UNITED STATES PATENT AND TRADEMARK OFFICE

10/698,427

Hideki Muto

Office Action Summary

第1図

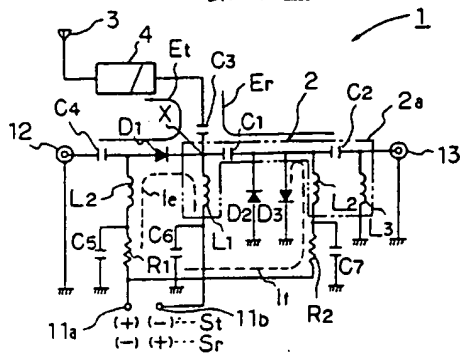
Similarly, Fig. 1 of Todoroki et al. discloses a high frequency switch component for being connected to a transmission circuit (not shown), a reception circuit (not shown) and an antenna 3, the switching component comprising: a high frequency switch including an inductor L1, a capacitor C1 and a diode D1 for switching between states in which either the transmission circuit or the reception circuit is connected to the antenna; a plurality of terminals including a ground terminal (shown schematically), a transmit circuit terminal 12 (note the transmit signal Et), a receive circuit terminal 13 (see receive signal Er) and an antenna terminal (not numbered) to be connected to ground, the

transmission circuit, reception circuit and antenna, respectively; and a first LC filter 2a that includes a first inductor L3, and the LC filter is a high pass filter such that it, and thus the inductor L3, inherently eliminates an electrostatic surge or discharge occurring on the signal line because it has low impedance to ground at low frequencies; and wherein the first inductor L3 is connected to the ground terminal and is provided between the reception circuit terminal 13 and a capacitor C2 provided adjacent to the reception circuit terminal 13 such that the first LC filter is also in the location recited, as far as the claims can be understood. Also, because the first inductor L3 is connected to ground, the first LC filter 2a that includes the first inductor is considered "connected to ground".
